ADDENDUM No. 4

**Walnut Street Bridge Repair and Rehabilitation
TDOT PIN: 128099.00
Federal Project Number: STP-M-9202(134)
State Project Number: 33LPLM-F3-229
Chattanooga Department of Public Works**

This Addendum #4, is being issued to provide:

1. Revised Special Provision SP-7 (Schedule)
2. Added Special Provision SP-8 (Guarantees and Warranties)
3. Revised Bid Item Form
4. Revised plan sheets 2, 4,4A, 4C,13, and E-0.3
5. Remainder of Questions and Answers

TYPICAL SECTION & TIMBER REPAIR ITEMS

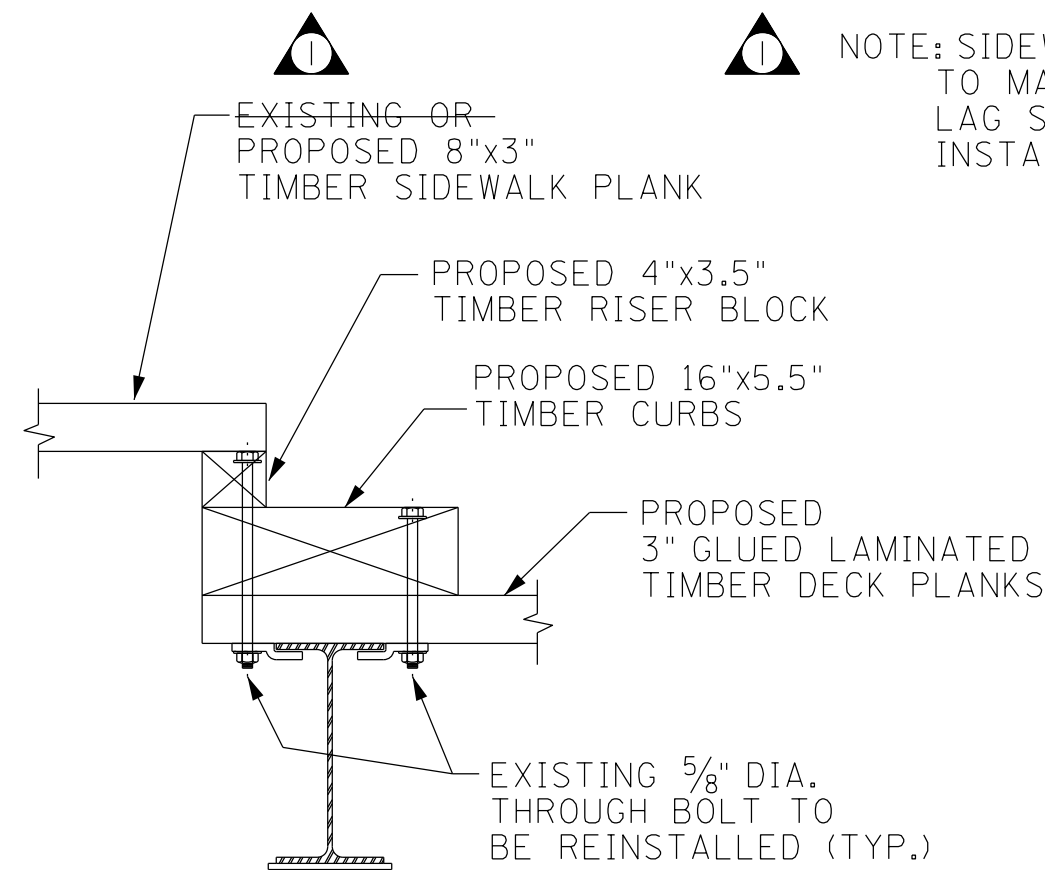
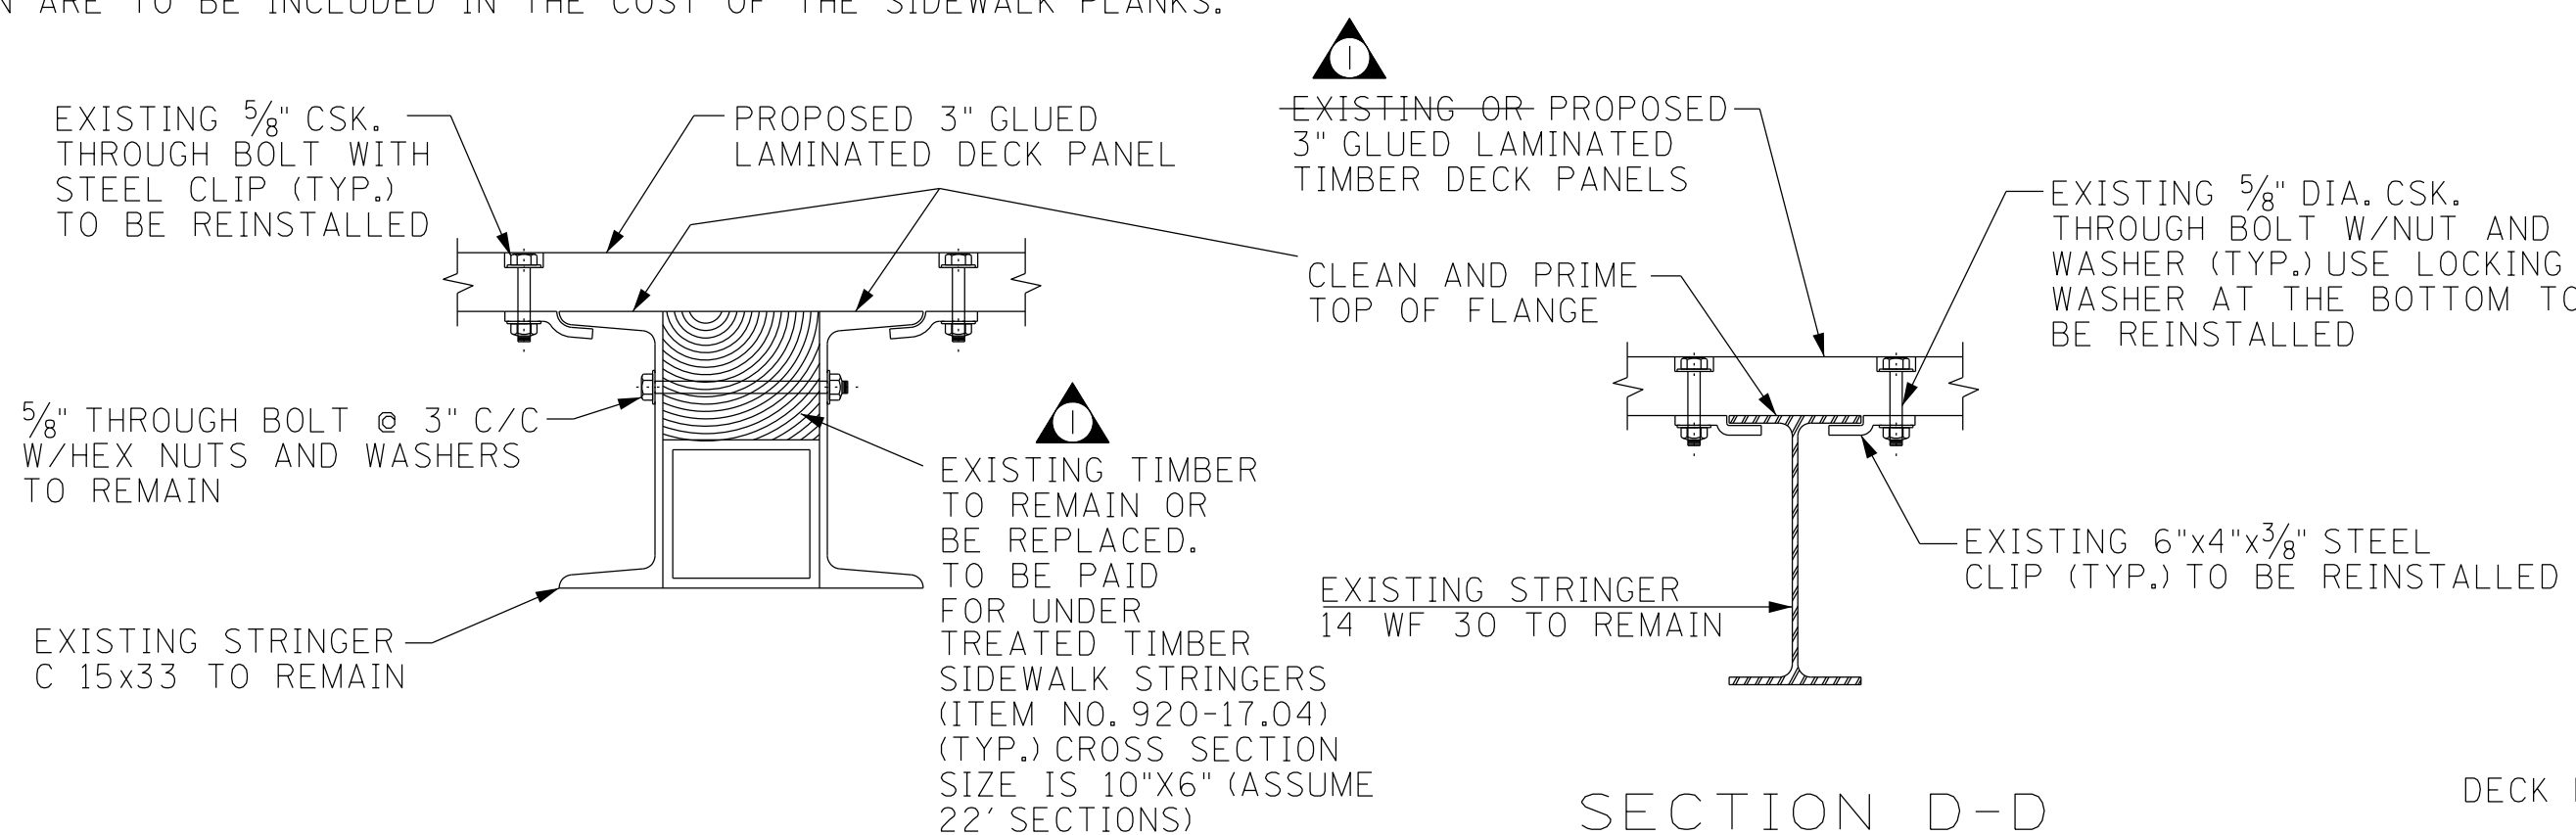
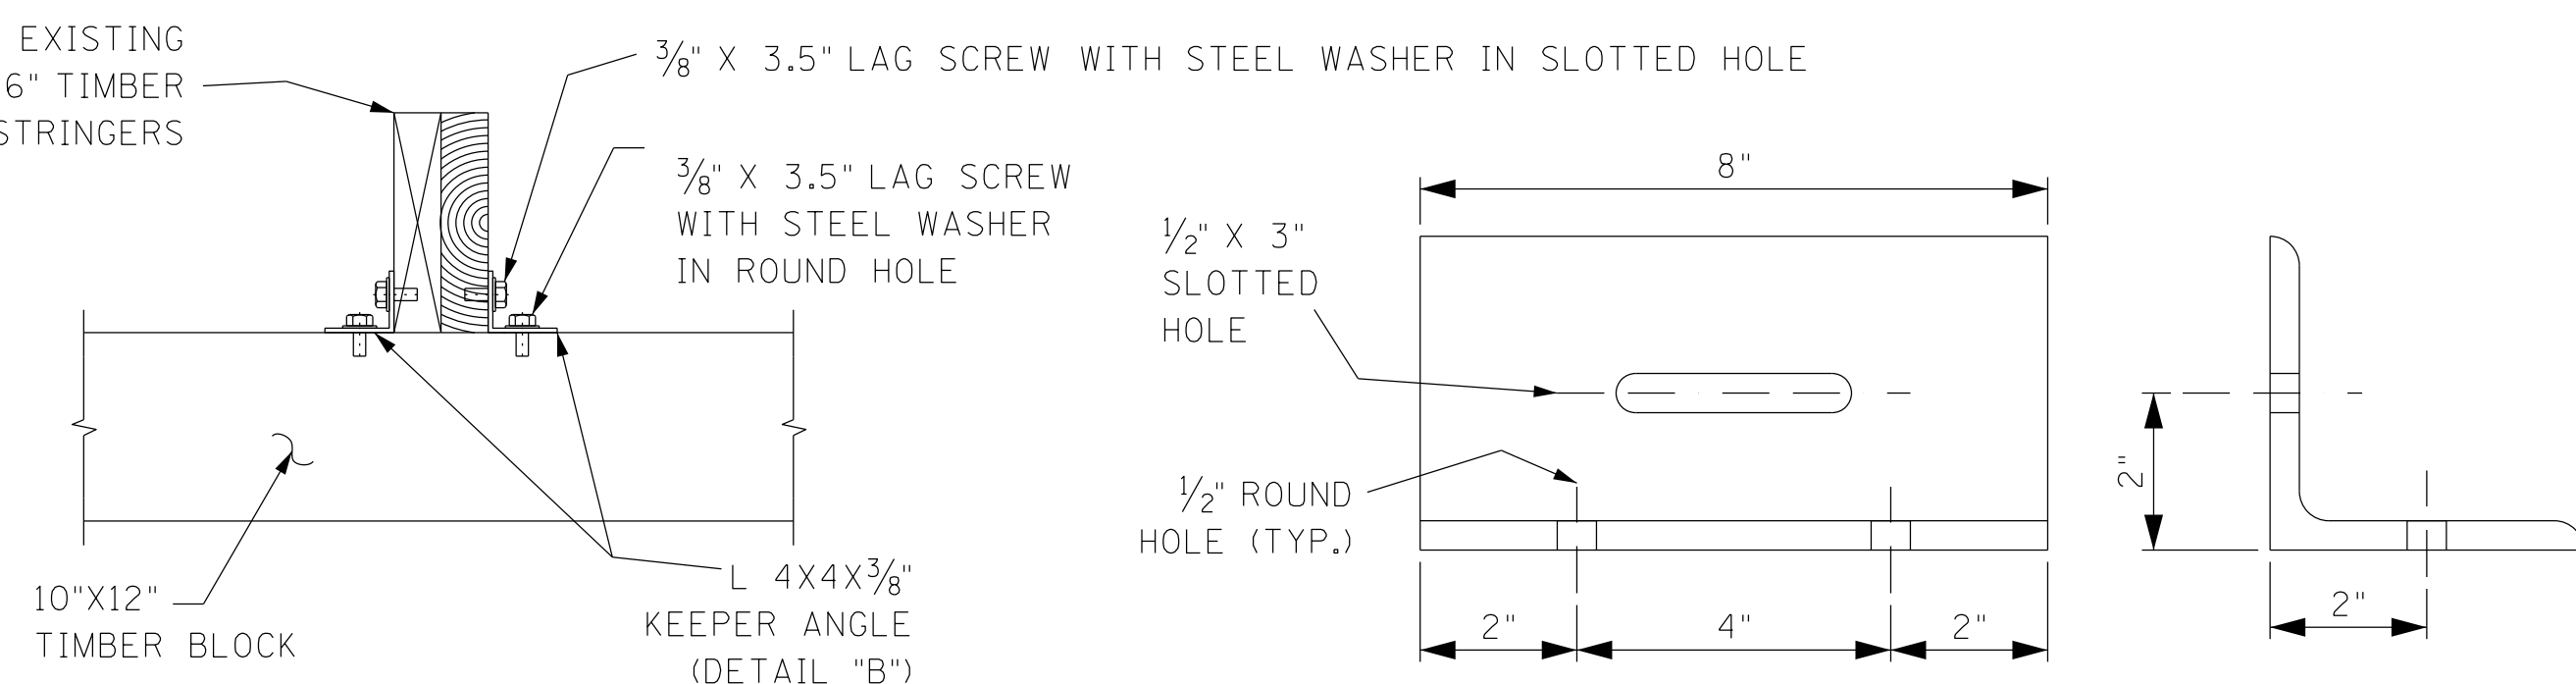
NOTE: SIDEWALK PLANKS TO BE FASTENED TO STRINGERS USING LAG SCREWS AND WASHERS TO MATCH THE EXISTING. EXISTING SCREWS AND WASHERS MAY BE USED IF IN GOOD CONDITION. LAG SCREWS ARE TO BE PREDRILLED AND COUNTERBORED. ALL LAG SCREWS, WASHERS, AND INSTALLATION ARE TO BE INCLUDED IN THE COST OF THE SIDEWALK PLANKS.

Can a detail be provided on how to fasten the sidewalk planks to the structure?	A revision will describe the fastener requirements.
Will a TDOT format cpm schedule be required?	Contractor to provide a TDOT format CPM schedule.
Can the owner provide the value of the fees referenced on page 141 section 1.05 of the specifications?	Contractor is responsible for verifying all required fees and/or charges associated with the project.
Will the 10"x12" Timber Blocks have to be removed in order to paint the tops of the floor beams?	Yes.
Plan Sheet 13 Does the top flange of the bridge stringer beams require paint removal and a new coating? It is not clear if this is required in the painting scope.	Yes.
We are in receipt of addendum No. 2 Even though it includes additional sections of the Truss/Stringer repairs, it only identifies the structural members that need repairs. Would you please be so kind as to forward us any as built drawings available identifying the structural members of the bridge, in order for our company to develop an accurate take off for the required painting. The said drawings would show the length/width/components of the vertical, diagonal and horizontal members of the structure in question. We would appreciate any effort on your part to do so.	All the plans that are available have been provided in addendum 2 and 3.
